Jean Fraser - Planner
City of Portland
Planning & Urban Development Department
389 Congress Street
Portland, ME 04101

January 17, 2014

Subject: Munjoy Heights
 Final Level III Site Plan – Conditions of Approval
 Comment Response Letter

CONSTRUCTION NOTES & DETAILS

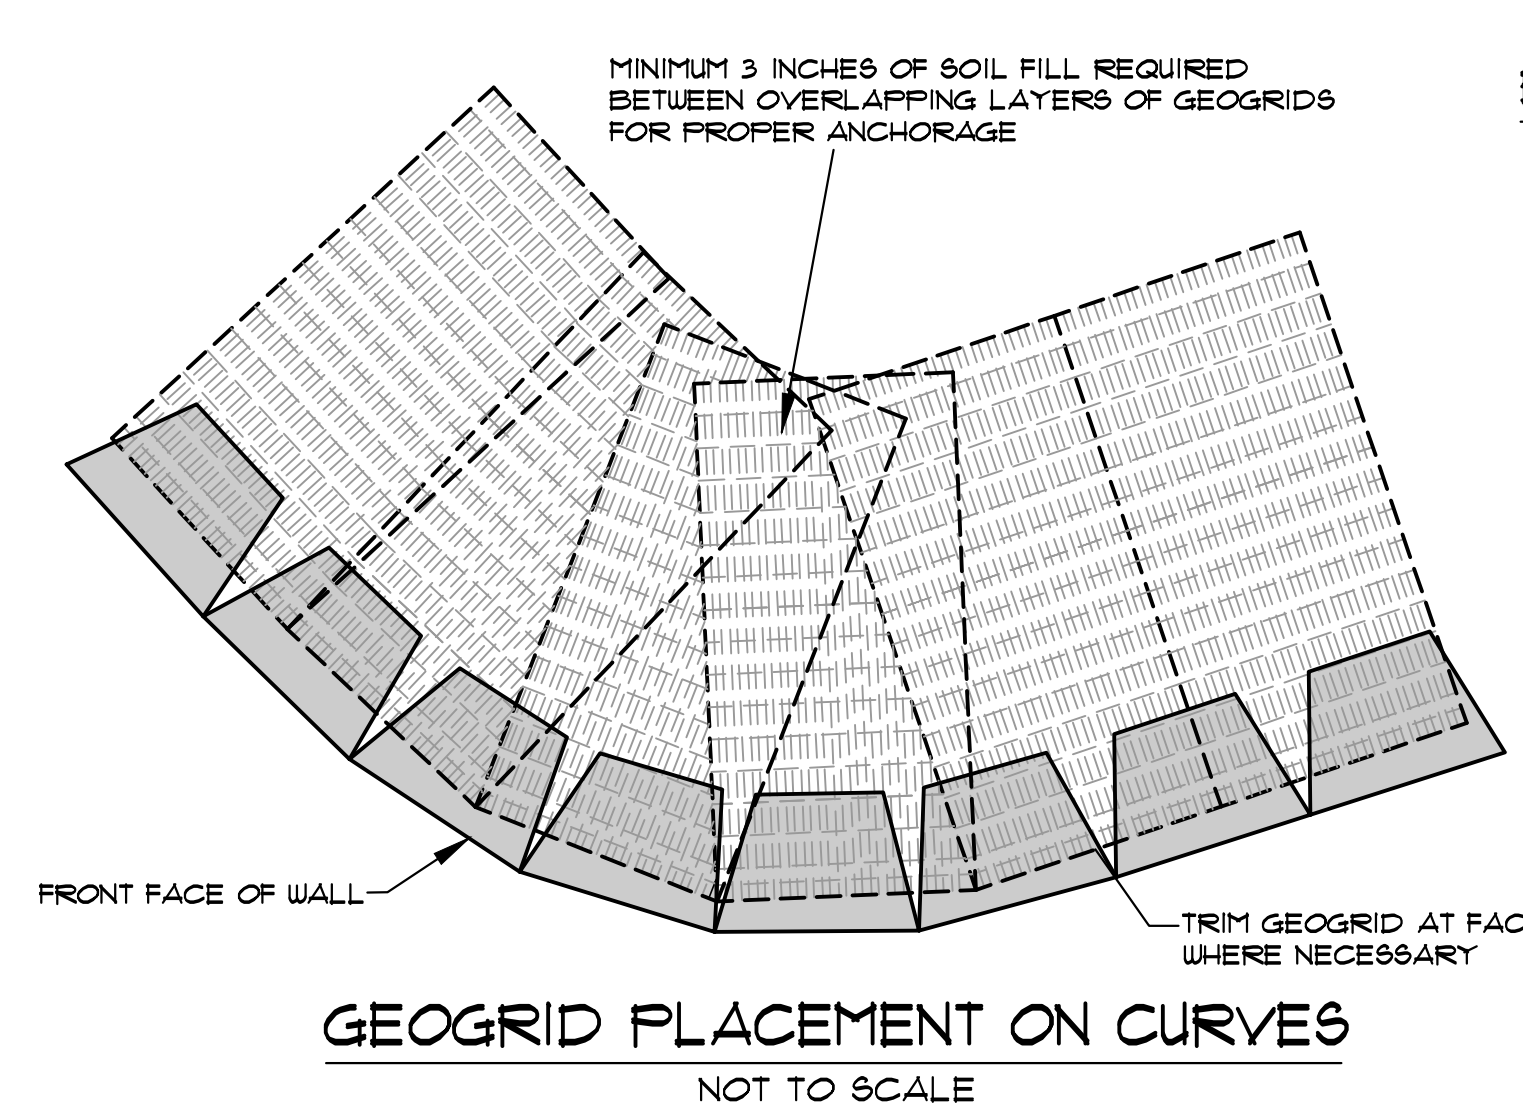
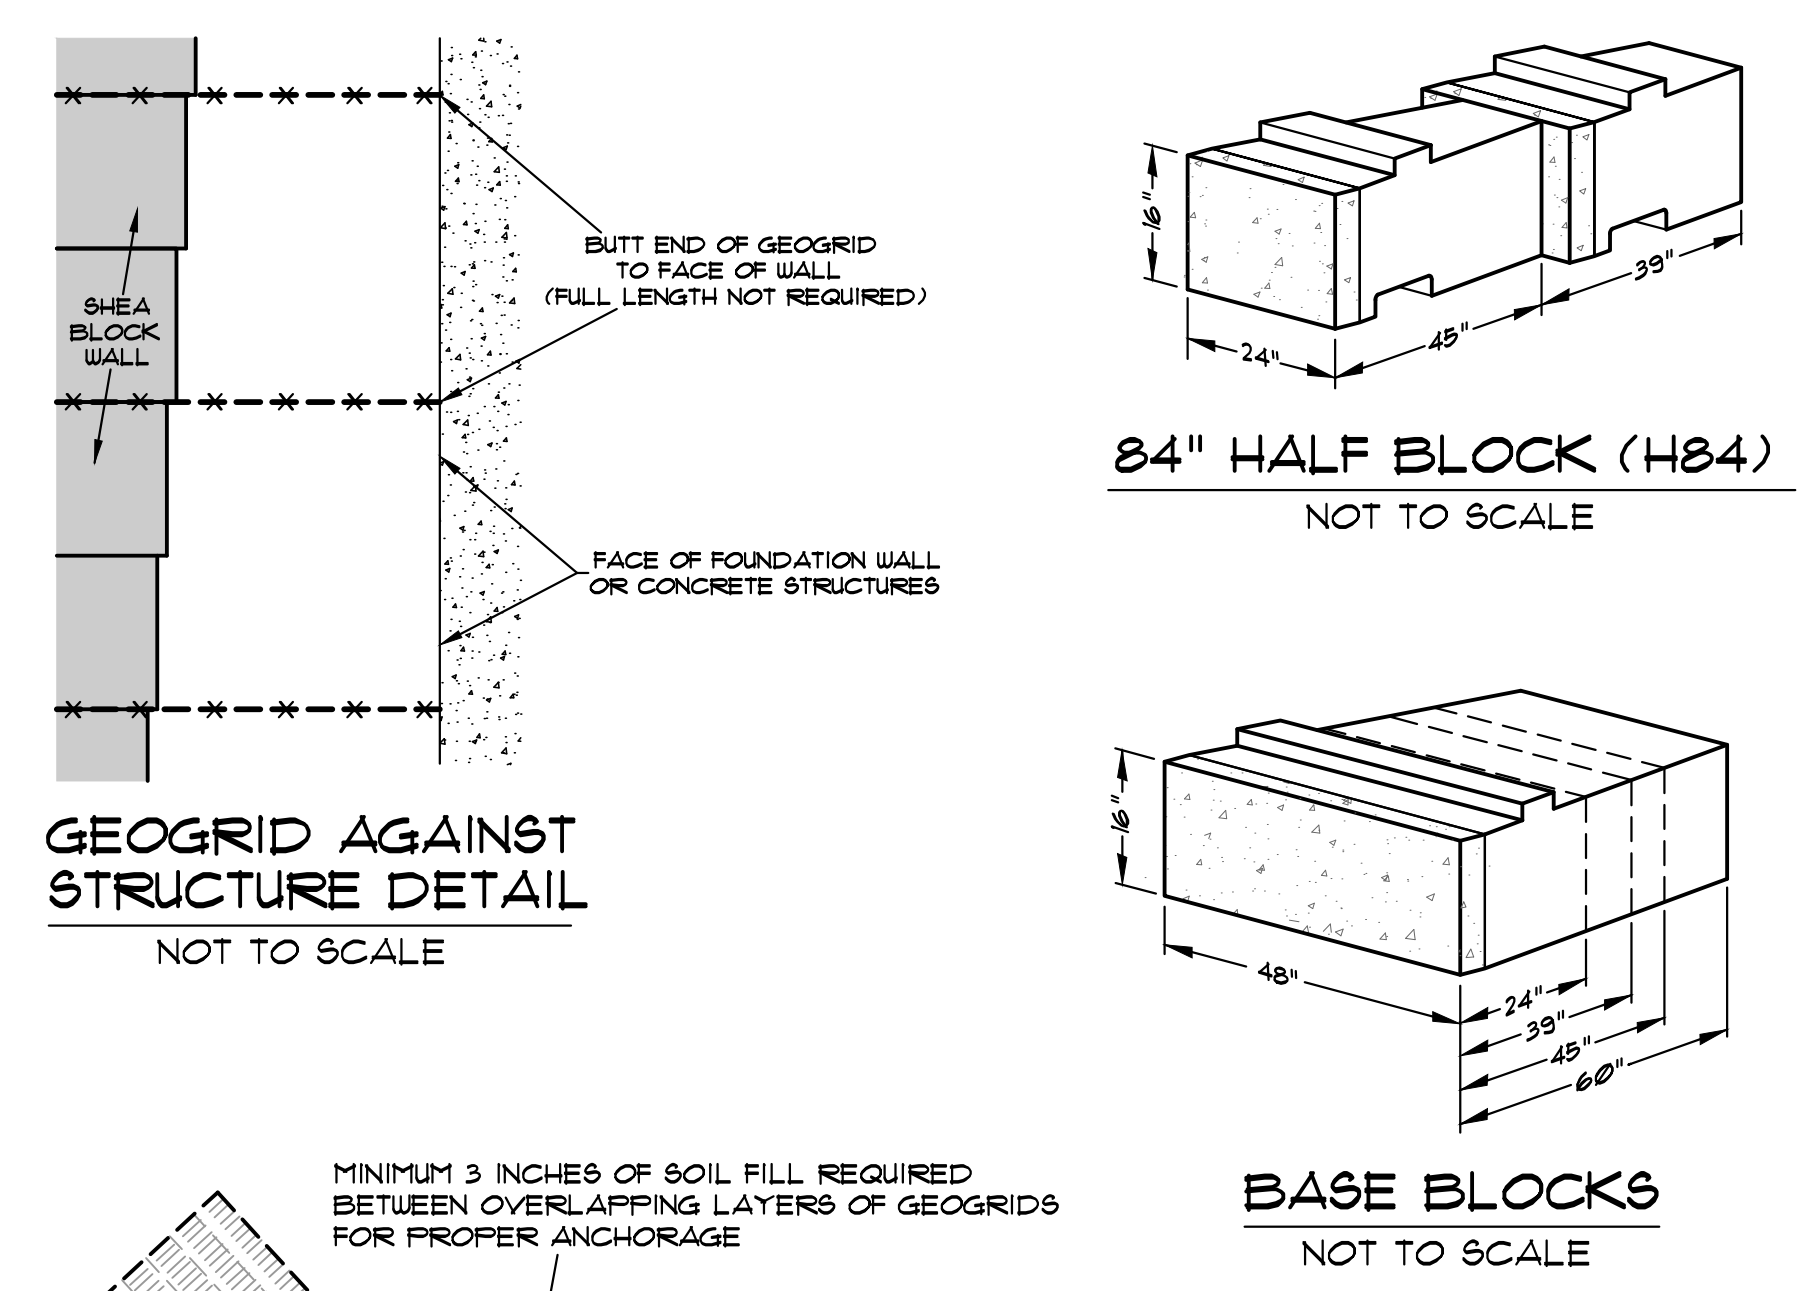
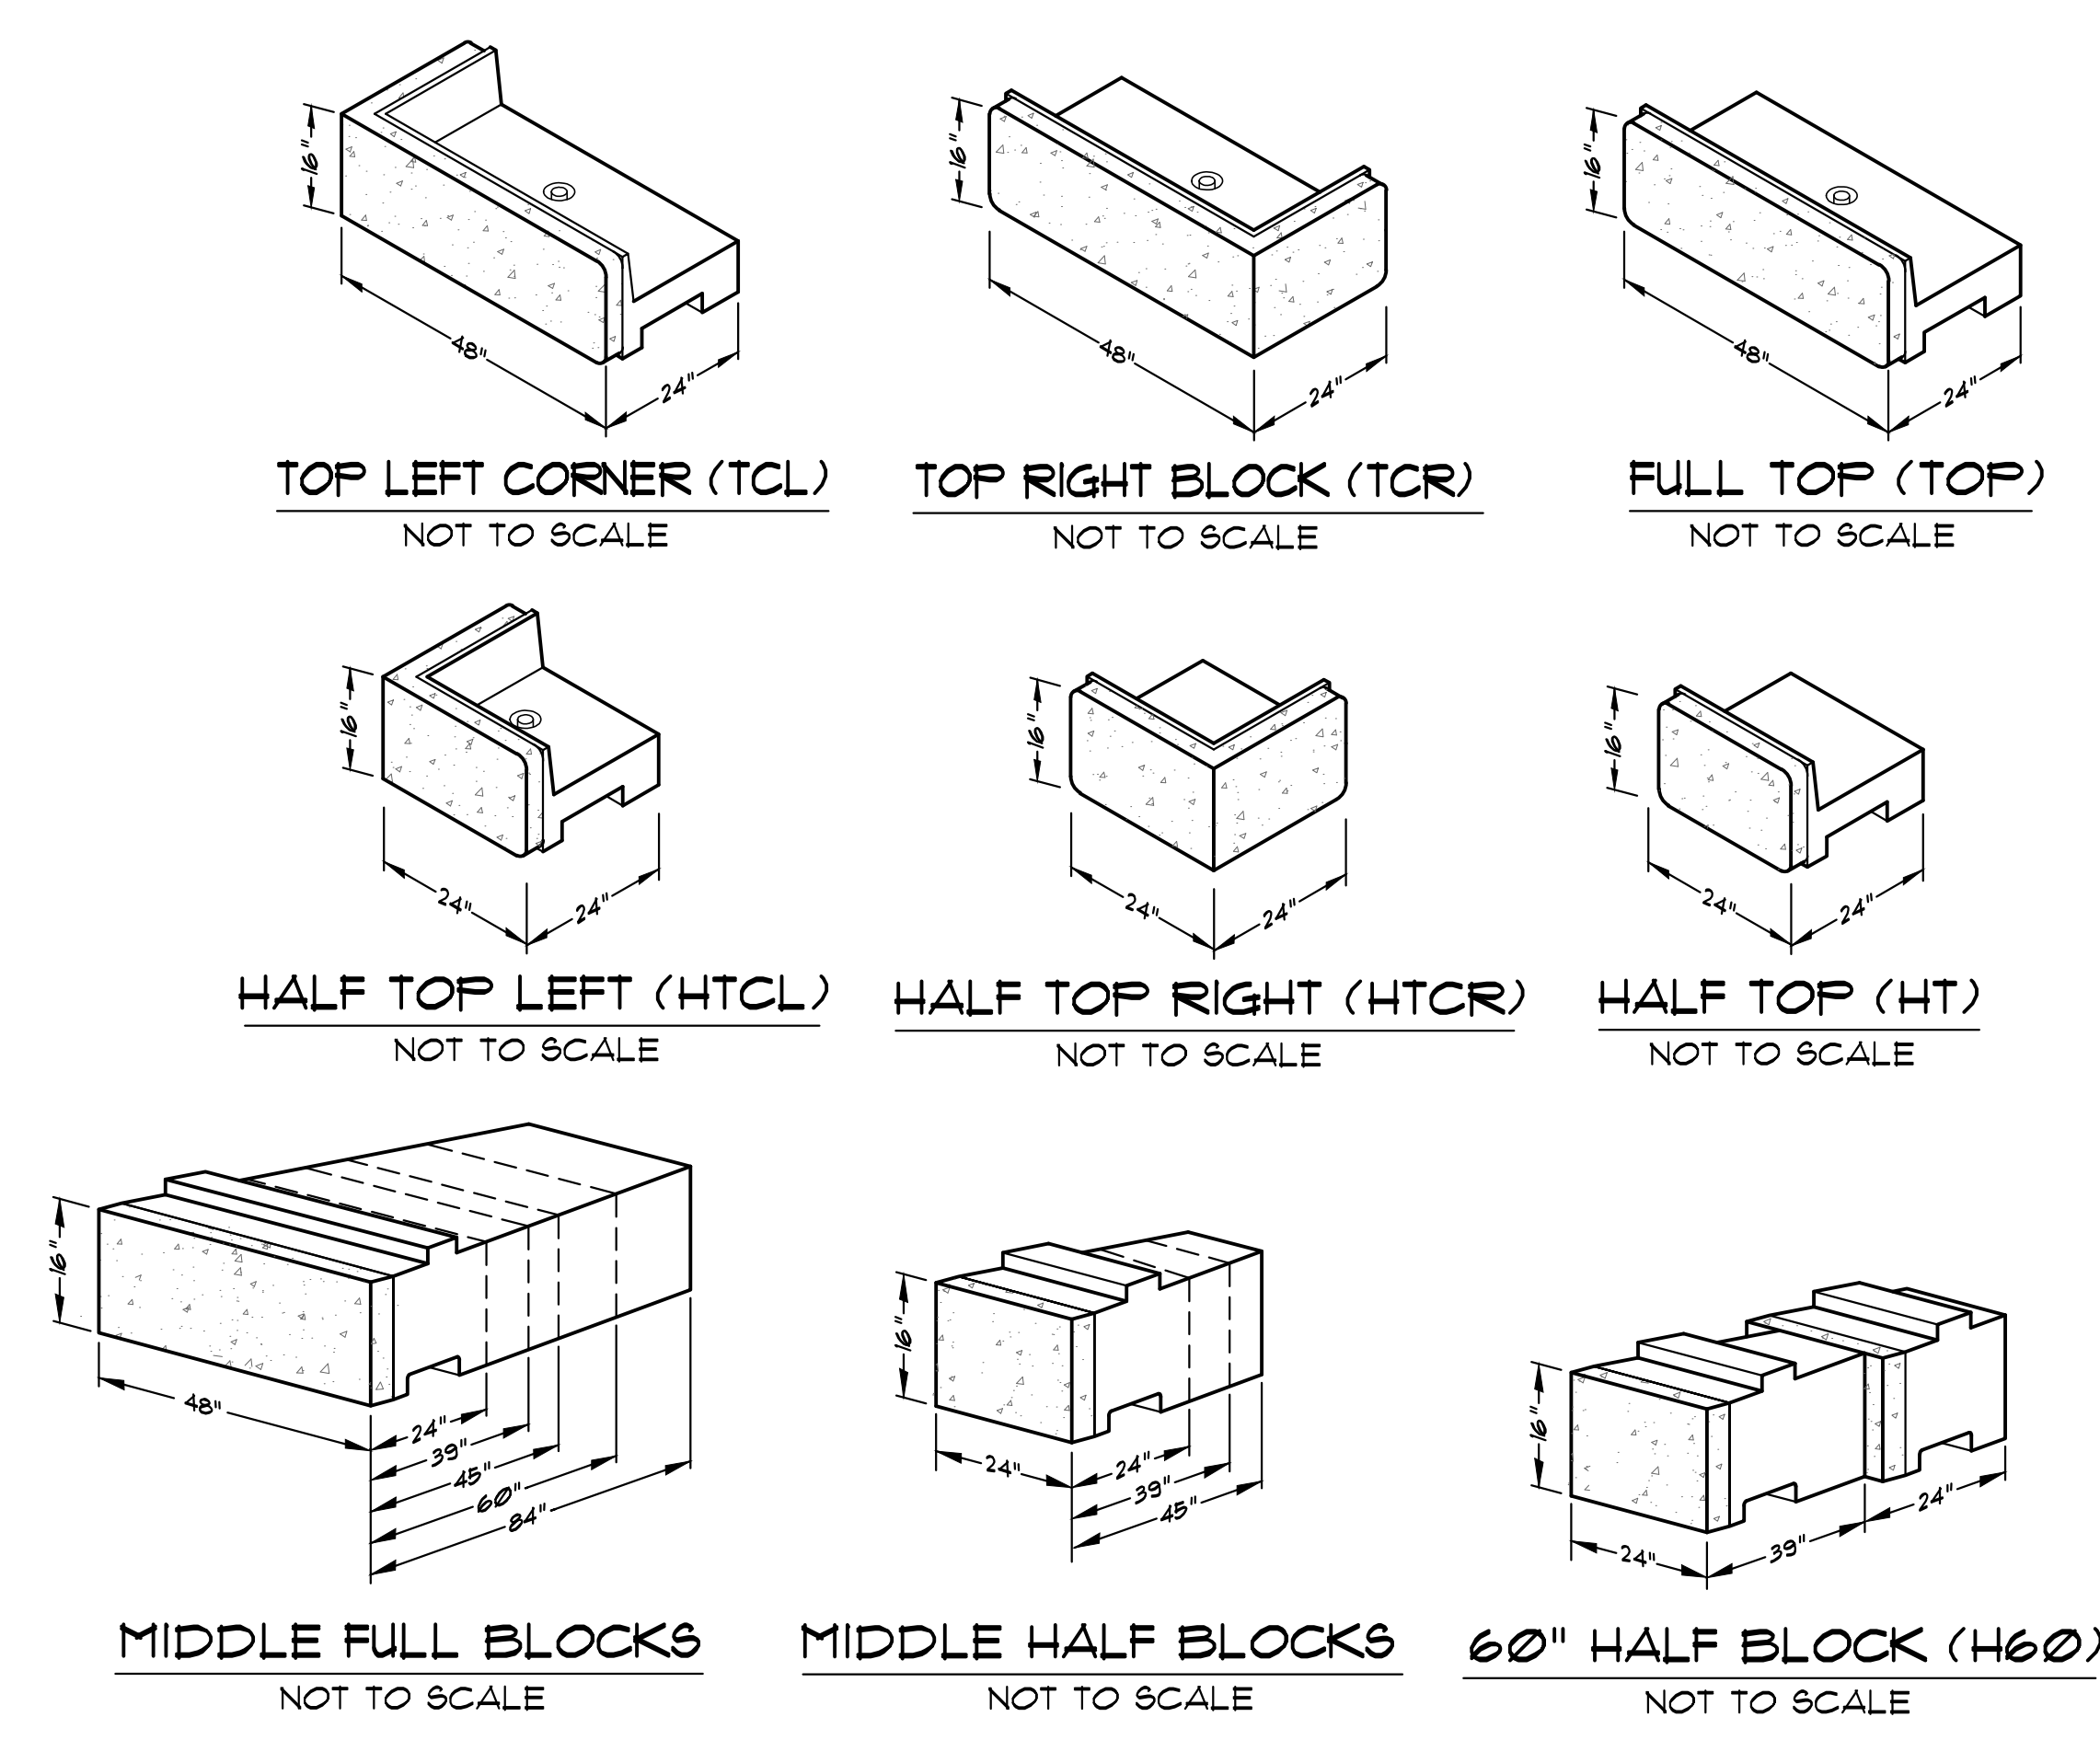
19) *In general we agree with the Applicant's proposal to provide "weep holes" at the base of the wall in lieu of a direct connection to the combined sewer in East Cove Street. The Applicant should include details and notes on the plans for the weep hole outlets to ensure that they are properly stabilized and that they do not direct concentrated flow onto adjoining properties. Per discussions with City DPS, the Applicant should design the retaining wall drainage system and weep holes to allow for a future connection to a hard-piped system if issues arise from groundwater flow. Additional notes and design details should be submitted for review and approval.*

#19: The following minor revisions were made to Sheet 3 of the SGS retaining wall drawings.

1) The crushed stone at the base of the wall is extended up to the ground surface in front of the wall to provide erosion protection. The concept is that the water flow out of the weep pipe, into the stone, and then percolates into the subgrade soil. This potential infusion of water into the stone base will not affect the integrity of the retaining wall.

2) A secondary underdrain is shown at the base of the crushed stone column behind the wall. This underdrain would be capped at its ends. If there is a problem with weep water flowing onto the adjacent property, the weep pipe outlets can be capped and the end of the secondary underdrain connected to the combined Sewer in East Cove Street.
